AGENDA
BIRMINGHAM DESIGN REVIEW BOARD
WEDNESDAY MAY 17, 2023
BIRMINGHAM CITY HALL, 151 MARTIN ST, COMMISSION ROOM 205, BIRMINGHAM MI *
******* 7:15 PM*******

SUBJECT: 34040 Woodward – Community Unity Bank – Design Review

SUBJECT: 220 Park – Clark Hill – Design Review

SOUTHWEST ELEVATION
SCALE: 1/4"= 1'-0"

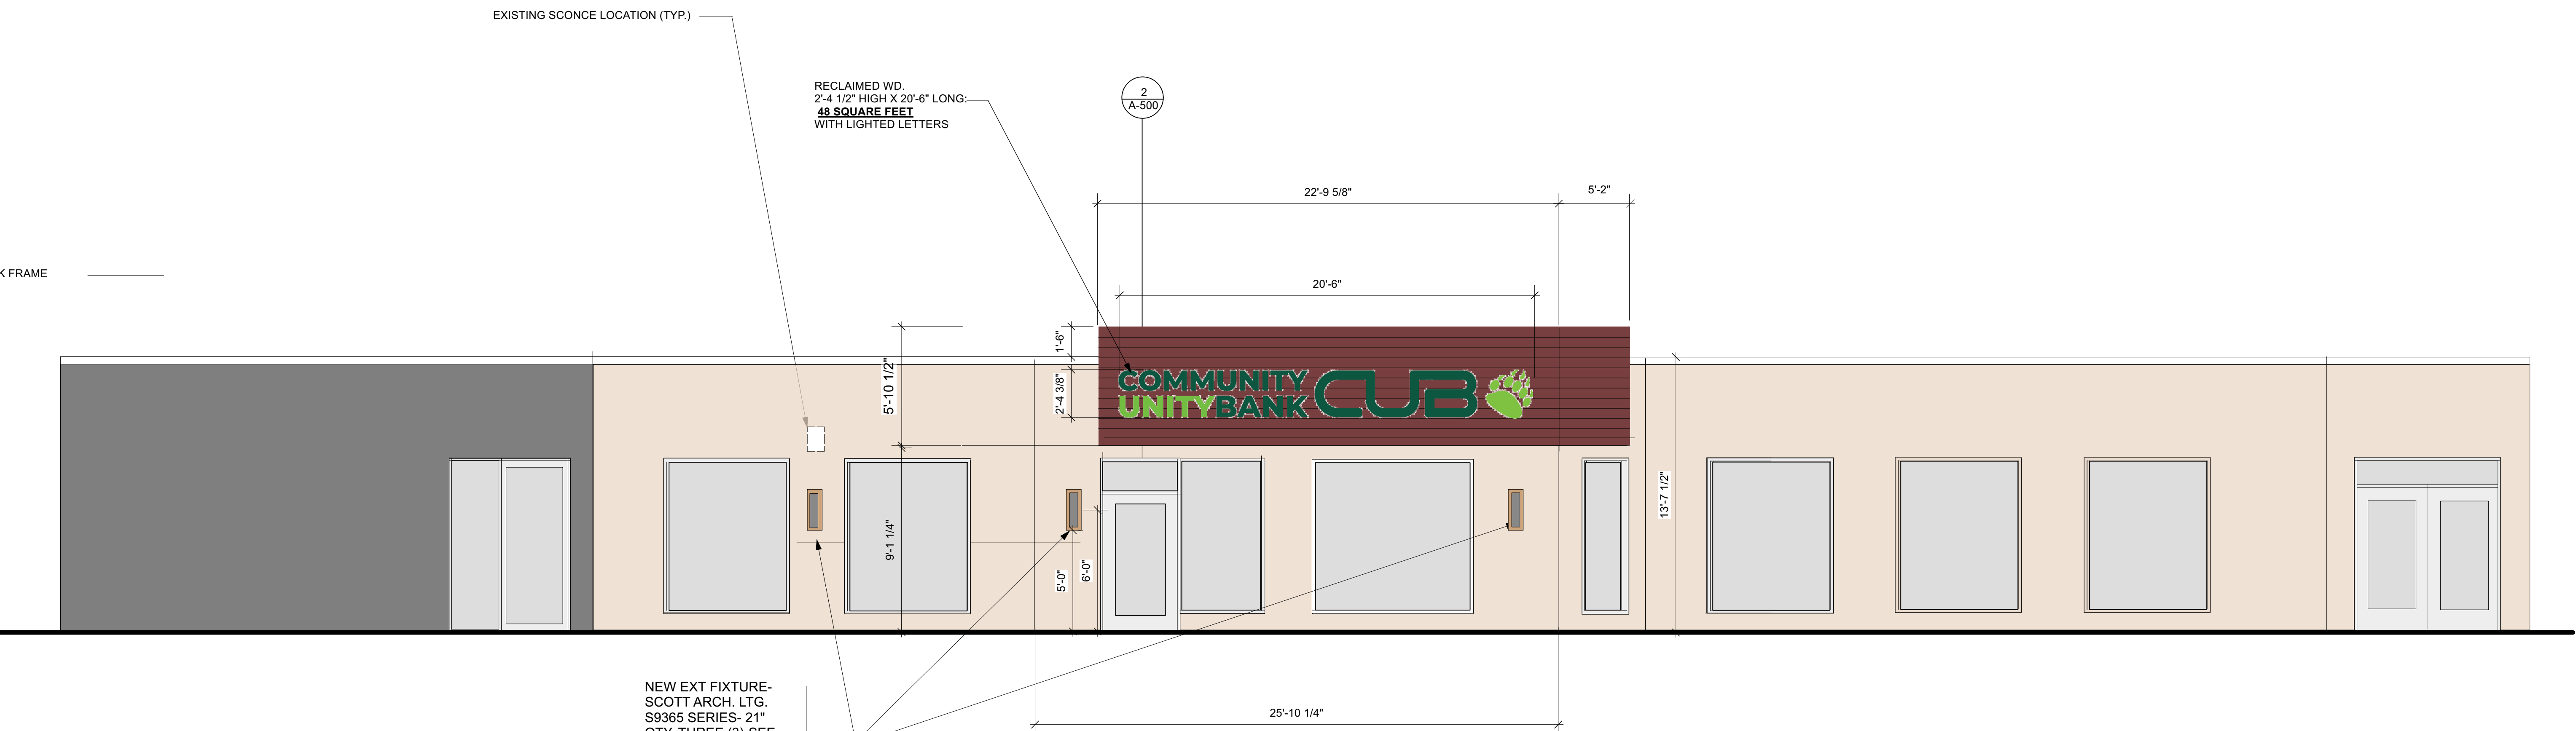
As this building is located within the Triangle District Overlay, there are specific architectural standards that must be followed. Per Article 3.09, Section (D) (1) of the Zoning Ordinance, “all walls exposed to public view from the street, or parking area shall be constructed of not less than 60% brick, stone or glass.” The architectural feature is proposed to be of reclaimed wood, but does not appear to bring the portion of the building constructed of brick, stone or glass, under 60%. The plan appears to meet all relevant standards under Article 3.09.

There is one new sign proposed as a part of the Design Review submitted. The sign is proposed as 7” internally lit letters with colors as shown on the sign plans provided. The letters would be mounted to a wood panel mounted on the building façade. The sign itself is proposed to be a name letter sign 48.47 sq. ft. mounted in the sign band.

The proposed Scott Arch. lights do not appear to be full cutoff as defined in Section 9.02. **Thus, the Design Review Board should discuss the proposed fixtures in regards to the six conditions listed above and determine if an exception will be granted.**

The 5 proposed Scott Arch. Lighting sconces will be replacing existing wall lights. The new wall sconces will be positioned lower on the wall. There are no dimensions included for height from grade, however the specification sheet shows the depth projection to be 4". **The applicant must submit revised plans to show the height from grade for the light fixtures.**

1. The Design Review Board APPROVES the non-cutoff light fixtures pursuant to Article 4, Section 4.21 (D) of the Zoning Ordinance.

TWO (2) EXTERIOR BUILDING SIGNAGE

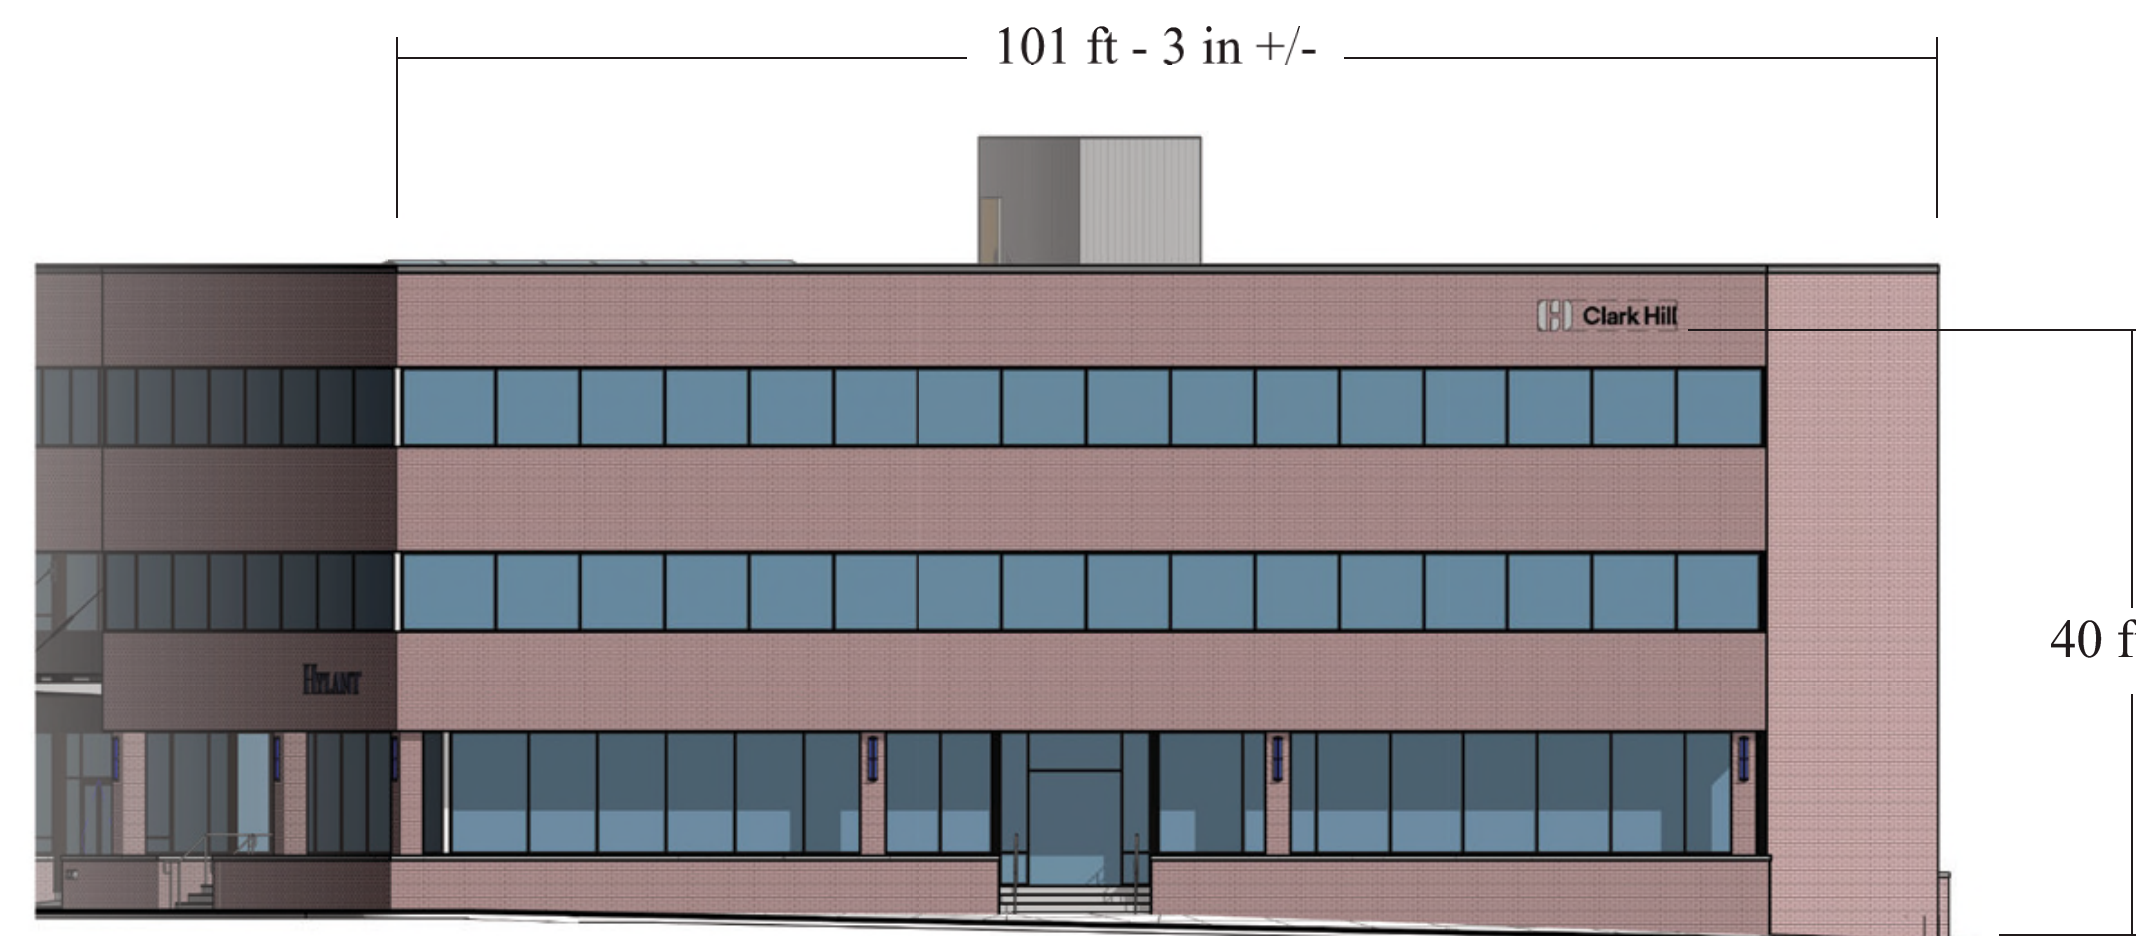
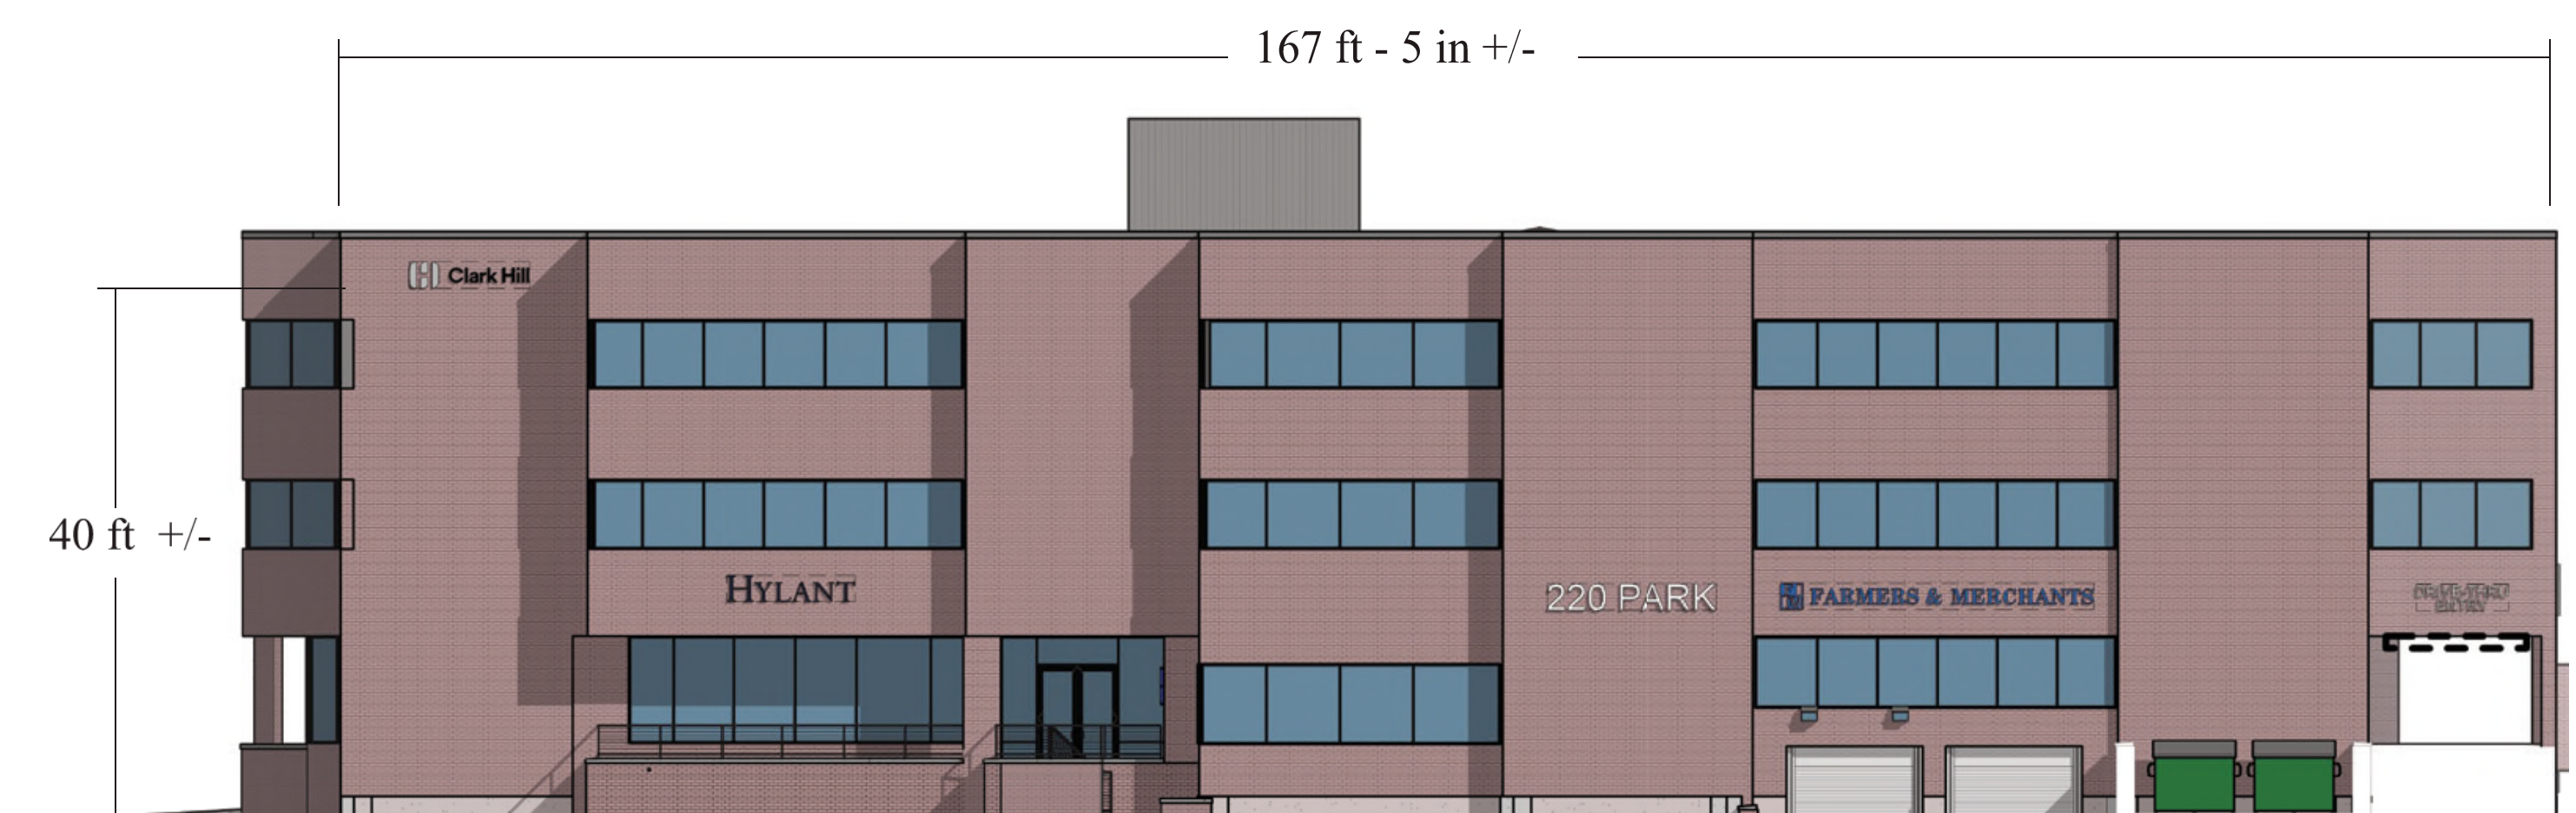
The applicant is proposing to have the 2 "Clark Hill" signs located above the sign band at the top of the building. The Sign Ordinance defines Sign Band as:

The "Clark Hill" signs are proposed as halo-lit channel letters that project a total of 3.5 inches from the building face. Illumination is not permitted for building identification signs. Thus, **the applicant must obtain a variance for 36.7 sq. ft. of illuminated building identification signage.**

In addition, there is one inconsistency in the plans submitted that show the "220 Park" sign in a previously proposed location. The Planning Division will work with the applicant to provide consistent drawings.

1. The applicant must obtain a variance for 36.7 sq. ft. of illuminated building identification signage; and
2. The applicant must submit revised plans to the Planning Division with consistent signage.
